FIELD INSPECTION

Project Name:	Mountain Valley Pipeline	Inspector:	Matthew Grant
Inspection Date:	Tuesday, September 3, 2019	Project Contact:	Brian Clauto
Spread: Montgomery County AR 266 MP225 MP223-224 Giles County AR256.02 MP217.1-215.7	Spread G	Weather (Wet/Dry/Rain):	Dry

FIELD INSPECTION PHOTO LOG

Fig. 1 AR266 check dam is at capacity for maintenance

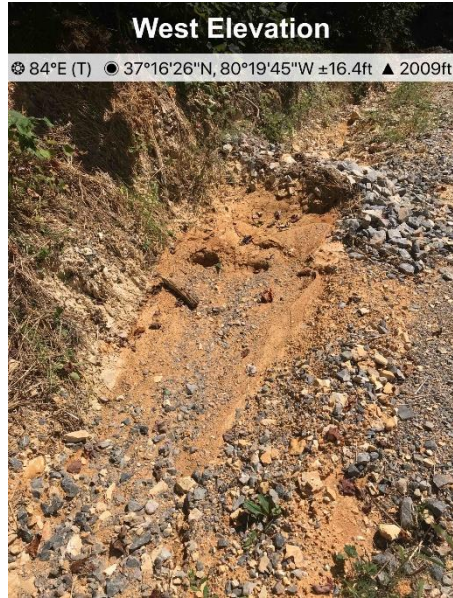
- Inspected designated streams included: S-0012, S-0013, S-0014
- ECD's inspected were in place at designated stream crossings.
- MP 216.4 waddle and P1 fence have holes and require maintenance
- Check dams at AR 266 are at a capacity that require maintenance

Recommend Corrective Action: Maintain and install all controls per the approved plan and specs
